## **Model Tricut**

## Centre nut

08-96 SSG11006

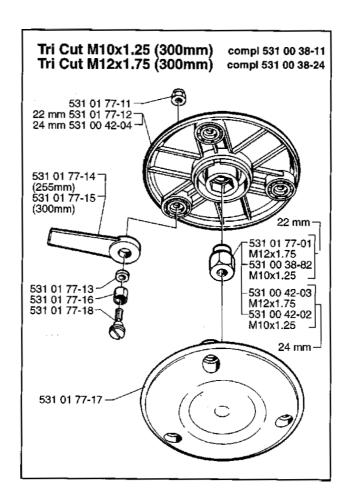
Our supplier of the Tricut head has modified the width across the flats of the centre nut from 22 mm to 24 mm. We must therefore stock both types during a transitional period.

This applies to centre nuts with both the M10 and M12 thread. The width across the flat must consequently be checked when ordering spare parts since both the 22 mm and the 24 mm versions are to be supplied during a given period.

N.B. As a result, the upper section to which the centre nut is fitted will also be available in two versions in the future. See illustration.
